**PR/0716/23**

## Record of Executive Business and Chief Executive's Order

**Reg. Reference:** SD22A/0286      **Application Date:** 24-Jun-2022  
**Submission Type:** Clarification of Additional Information      **Registration Date:** 26-May-2023

**Proposed Development:** Demolition of 2 sheds and the construction of 30 dwellings; 1 vehicular and pedestrian link with Main Street, Newcastle; vehicle and pedestrian link with Glebe Square, Newcastle and all associated and ancillary site development works.

Figure 2 Road's layout of 2012 LAP for Newcastle

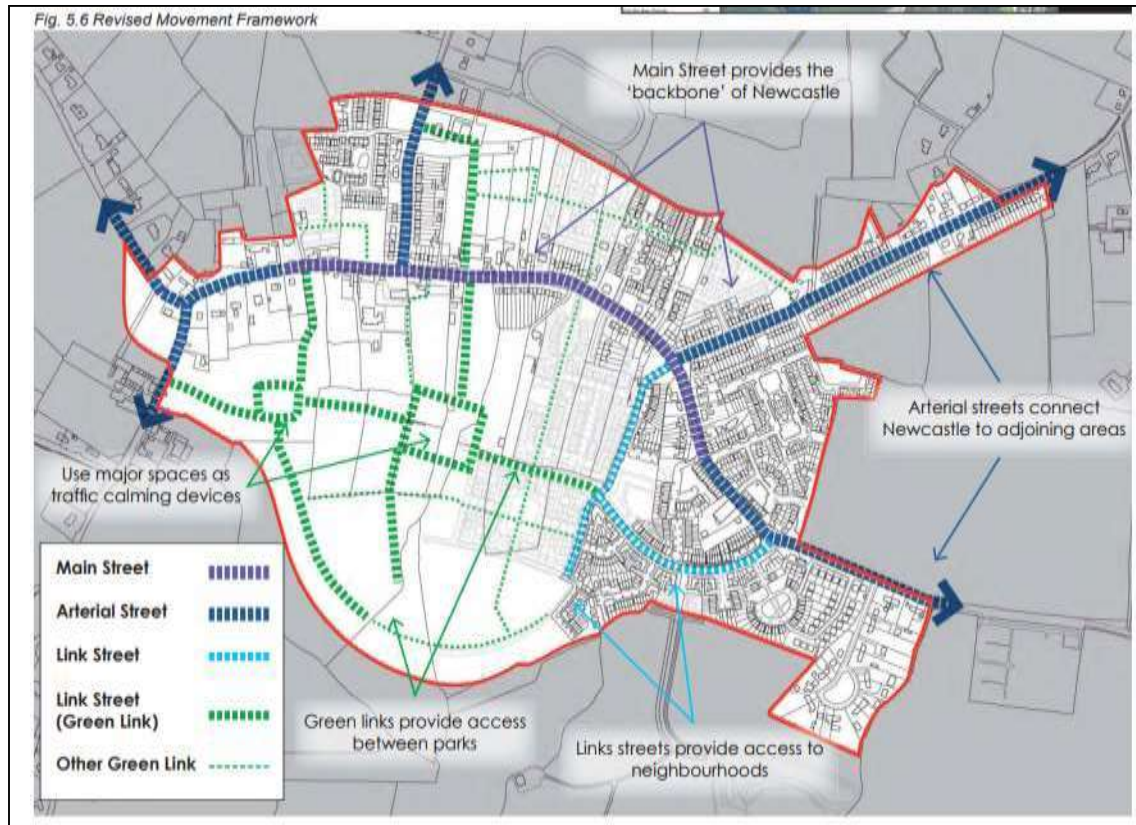
*The development has two vehicular access locations and an additional pedestrian access. The link road through the development to neighbouring Glebe development matches the layout from the 2012 Newcastle LAP. The link to Newcastle Glebe was proposed in a planning application dating back to 2000, shown in Figure 1.*

*The applicant has not provided details of the proposed connection to the Glebe Square Development, the existing boundary wall treatment is required. The applicant should provide an elevation detailing this vehicle access location.*
